ACCESSION NBR: 8205060368      DOC. DATE: 82/04/29      NOTARIZED: NO      DOCKET #  
 FACIL: 50-315 Donald C. Cook Nuclear Power Plant, Unit 1, Indiana & 05000315  
 50-316 Donald C. Cook Nuclear Power Plant, Unit 2, Indiana & ~~05000316~~  
 AUTH. NAME      AUTHOR AFFILIATION  
 HERING, R.F.      Indiana & Michigan Electric Co.  
 RECIP. NAME      RECIPIENT AFFILIATION  
 DENTON, H.R.      Office of Nuclear Reactor Regulation, Director

SUBJECT: Forwards addl info re NUREG-0737 Items II.F.1.4, II.F.1.5 &  
 II.F.1.6 re containment pressure, water level & hydrogen  
 monitors respectively, in response to 820316 request.

Donald C. Cook Nuclear Plant Unit Nos. 1 and 2  
Docket Nos. 50-315 and 50-316  
License Nos. DPR-58 and DPR-74  
REQUEST FOR ADDITIONAL INFORMATION ON TMI ACTION ITEMS  
II.F.1.4, 5 and 6

**FIGURE - 1** SECTION OF CONTAINMENT DETAILING  
LOCATION OF HYDROGEN MONITORING  
SAMPLE PORTS ESR-2, 5, 6, 8, 9

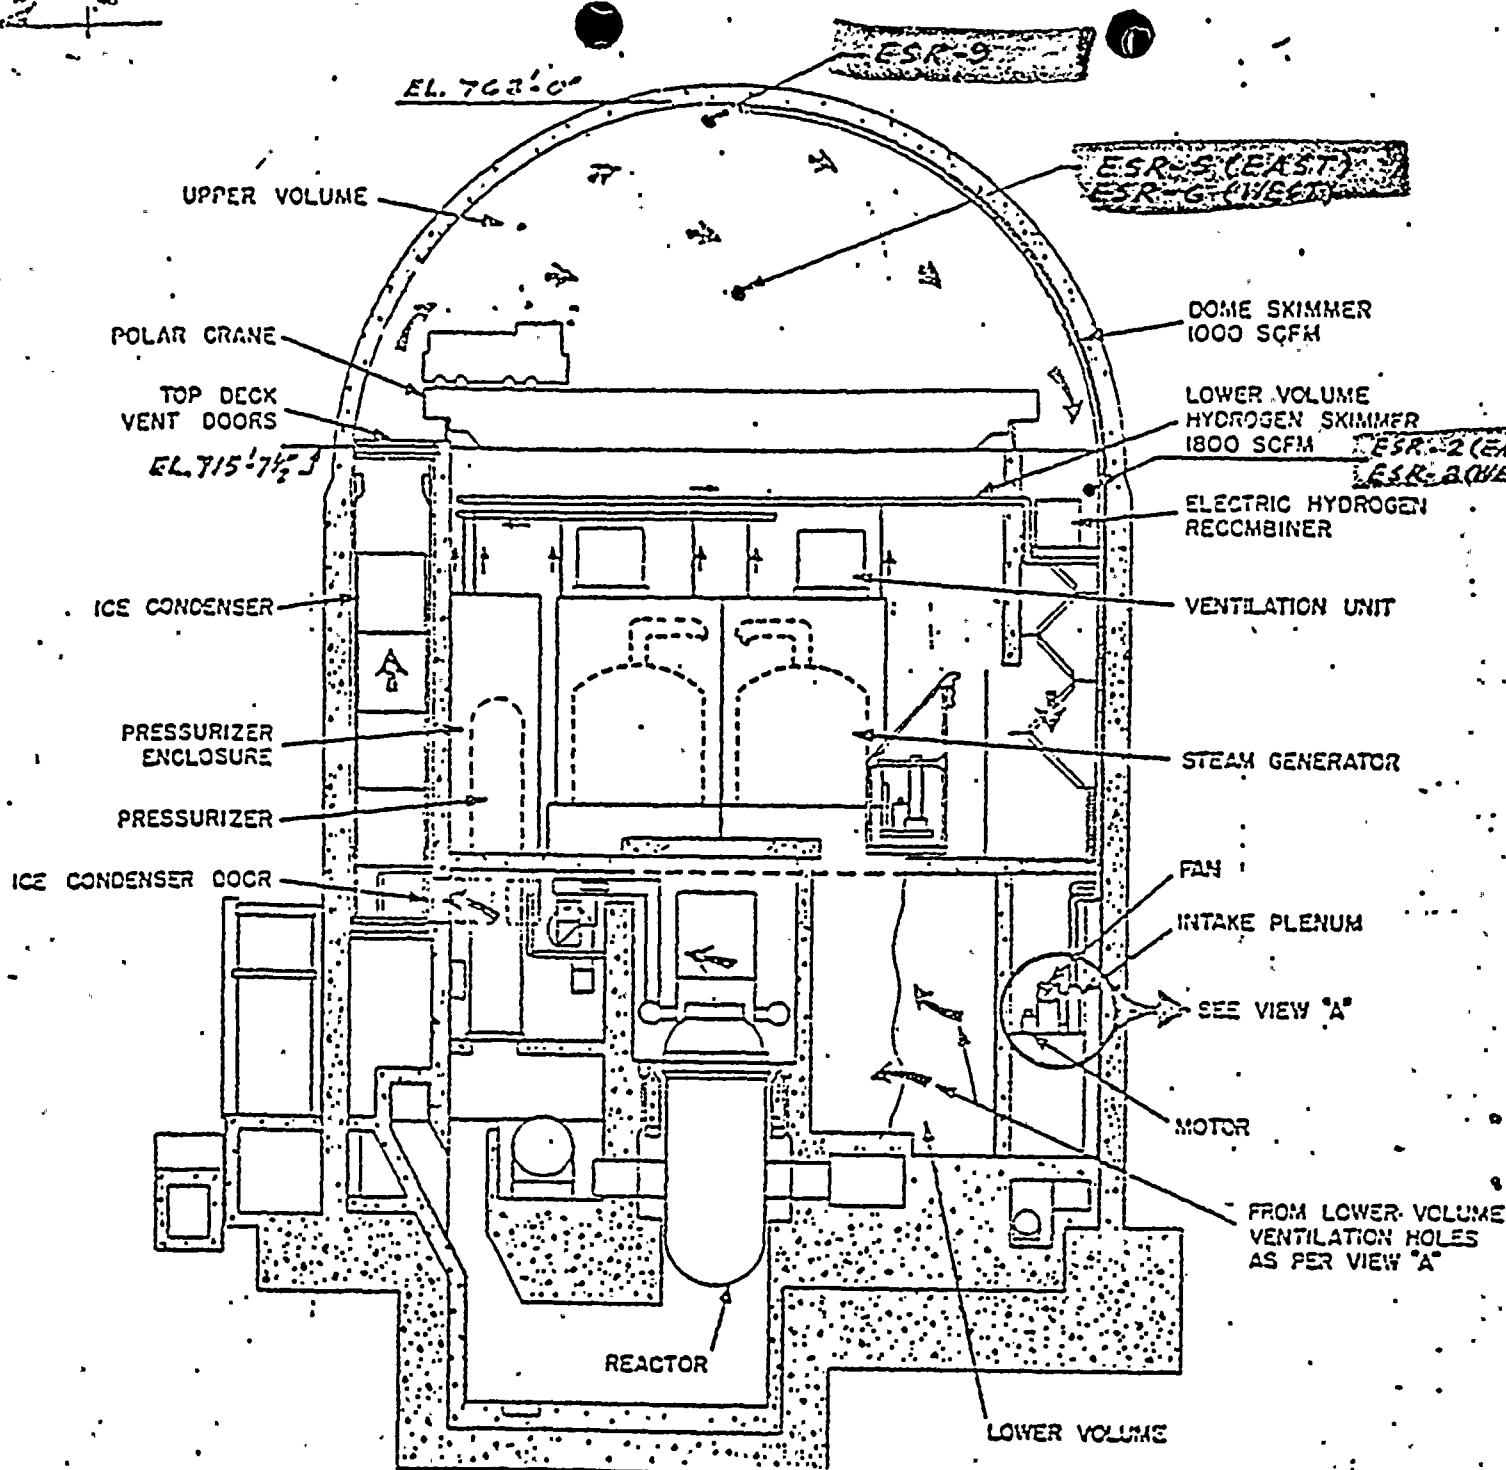
Q5. (II.F.1.6) Where are the hydrogen sample ports placed?

A5. There are nine (9) locations within the containment building -- seven (7) in the upper compartment and two (2) in the lower compartment. These provide representative sampling of the containment atmosphere for hydrogen following a loss of coolant accident. The location of each area sampled is noted in the attached Figures 1, 2 and 3. The hydrogen sample locations (ports) are identified as ESR-1 to ESR-9 and are located at:

<u>Sample No./</u> <u>Compartment</u>	<u>Location</u>	<u>Approx.</u> <u>Elevation (Ft.)</u>
ESR-1(U)	Steam Generator No. 4 Outside Enclosure Wall	692
ESR-2(U)	East Recombiner Outlet	705
ESR-3(L)	Lower Containment - East	645
ESR-4(L)	Lower Containment - West	645
ESR-5(U)	Containment Dome - East	743
ESR-6(U)	Containment Dome - West	743
ESR-7(U)	Steam Generator No. 3 Outside Enclosure Wall	692
ESR-8(U)	West Recombiner Outlet	705
ESR-9(U)	Top of Containment Dome - Center	767
